## ***Environmental Planning Commission***

**Agenda Number: 2**  
**Project #: 2021-005301**  
**Case #: SI-2021-00452**  
**Hearing Date: June 17, 2021**

### ***Staff Report***

<b>Agent</b>	Tierra West LLC
<b>Applicant</b>	Western Hills Investments LLC
<b>Request</b>	<b>Major Amendment to Site Plan –EPC</b>
<b>Legal Description</b>	Tract C-4-A, plat of Tracts C-3-A, C-3-B, C-3-C, and C-4-A, Seven Bar Ranch Addition
<b>Location</b>	On NM 528/Alameda, north of Ellison Dr. NW and east of Coors Bypass NW/Coors Blvd. NW (3615 NM 528)
<b>Size</b>	Approximately (≈) 2 acres
<b>Zoning</b>	NR-BP

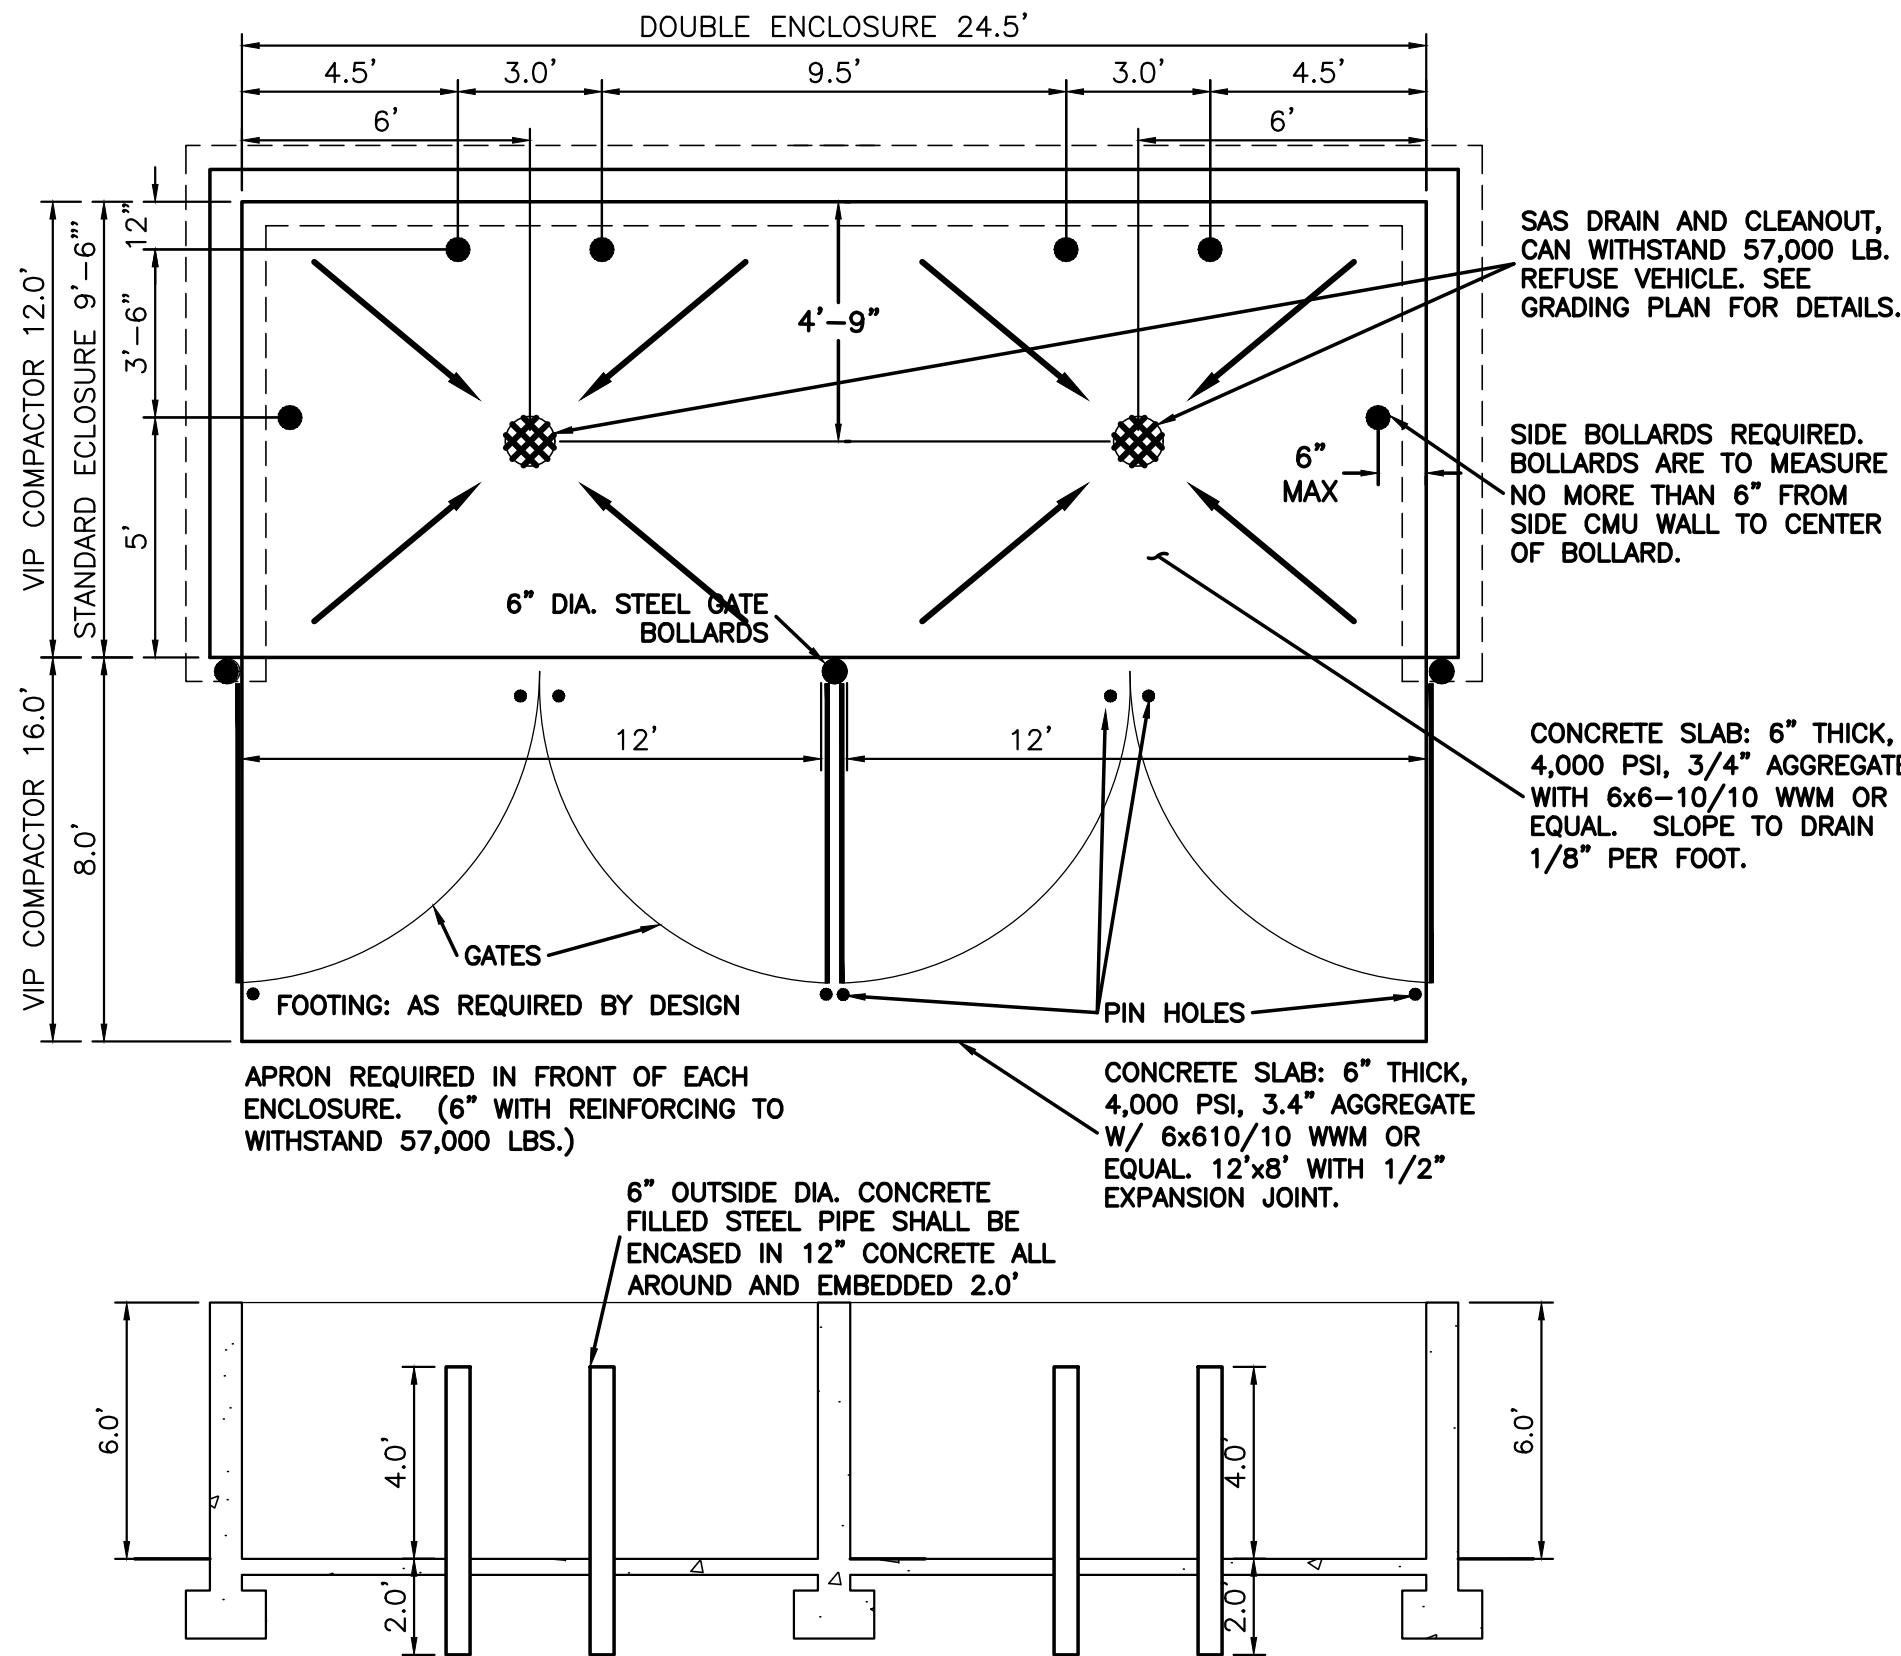
*14-16-5-5 Parking and Loading:* Parking calculations are shown on the first sheet (C-1). Required parking was calculated using the rate for Restaurant, which is 8 spaces/1000 sf. For the Phase I building, 8 spaces are required. 24 are provided. For the Phase II building, 27 spaces are required and provided. 2 handicap spaces (included in parking total) and 2 motorcycle spaces (in addition to parking total) are provided for each building.

revised to use the gross lot area specified on the main site plan (Sheet C-1), which is 86,684 sf. Minus 4,300 sf of buildings, the net lot area is 82,384 sf. 15% of the net lot area is 12,358 sf.

Additional landscaping needs to be added to achieve the minimum requirement. Approximately 9,700 sf of landscaping coverage is provided and 12,358 sf is required. Staff suggests adding landscaping to the area near the proposed detention pond to help screen the pond and the drive-thru lanes. The landscaping is required to comply with minimum plant sizes at installation pursuant to 14-16-5-6(C)(6).

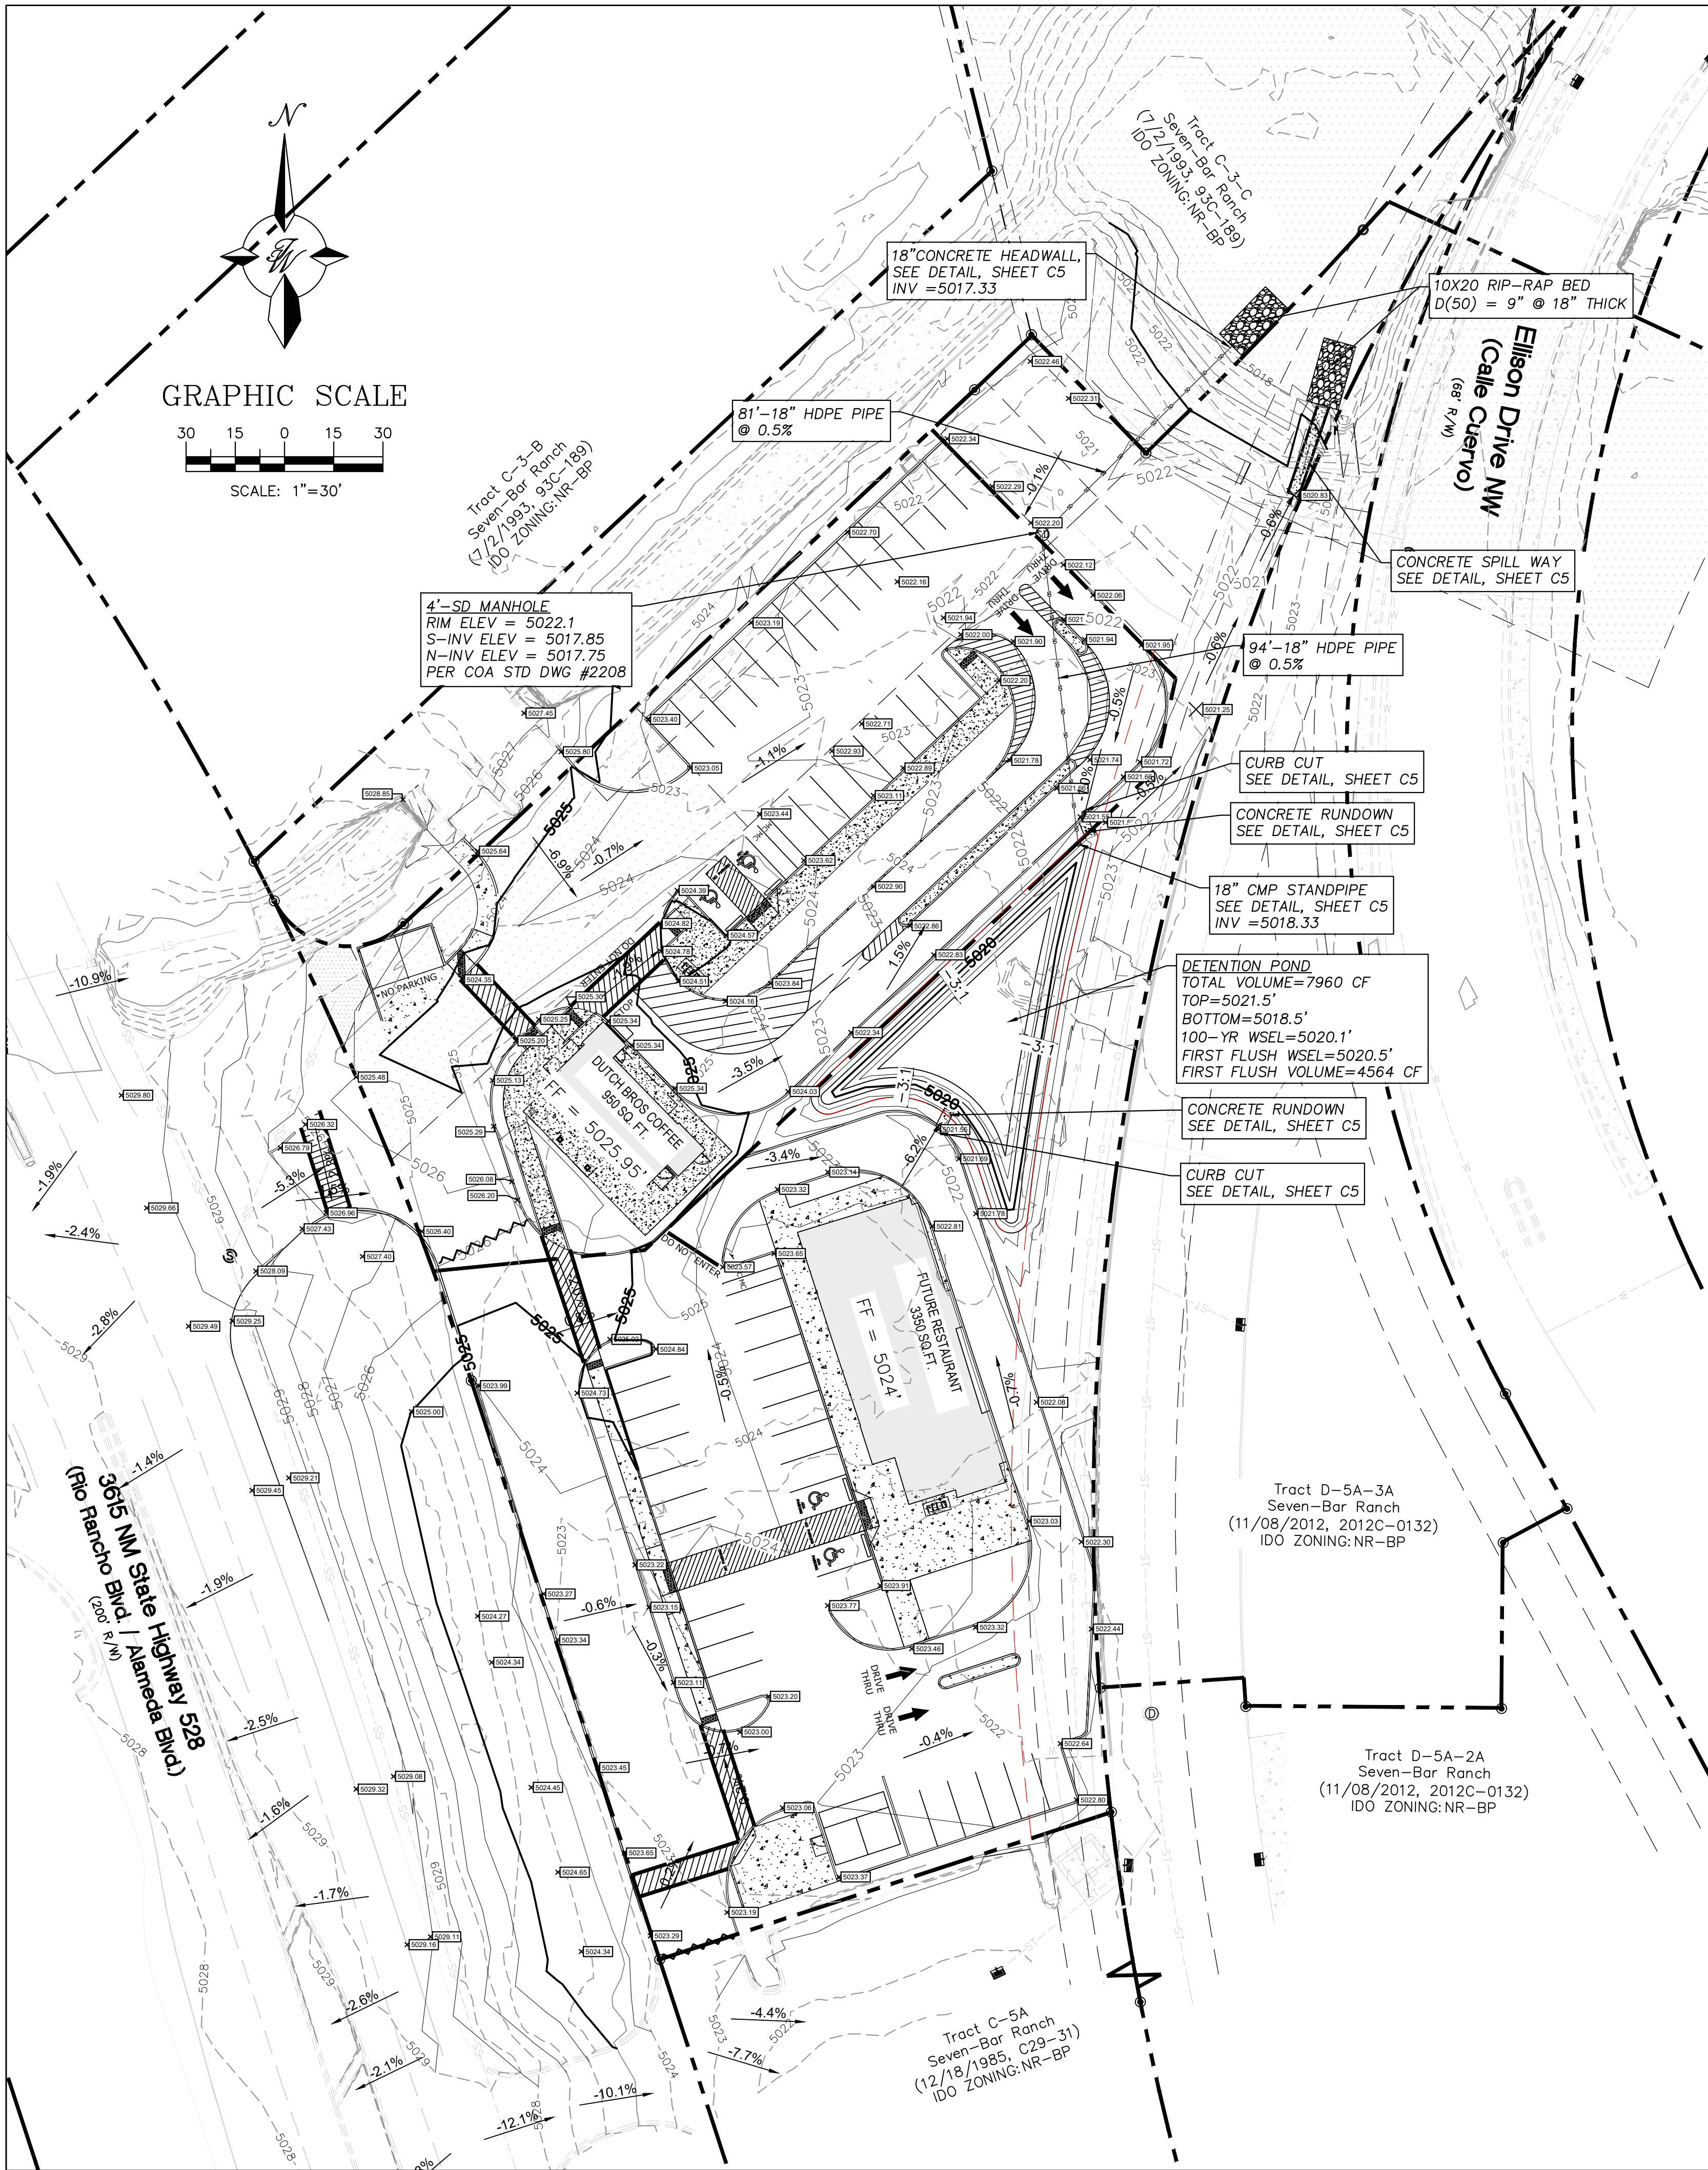
Water generally flows from west to east across the subject site, though it is relatively flat (elevations range from 5,025 feet to 5,020 feet). Curb notches for water harvesting need to be shown and match those shown on the landscaping plan.

The subject site is not located in a flood plain, though two drainage facilities are relevant. A detention pond exists on the eastern side of the subject site. Three concrete run-downs are also on the eastern side. The tract adjacent north is owned by AMAFCA and contains another detention pond (the Octopus Pond). The existing AMAFCA drainage easement needs to be shown on the site plan.
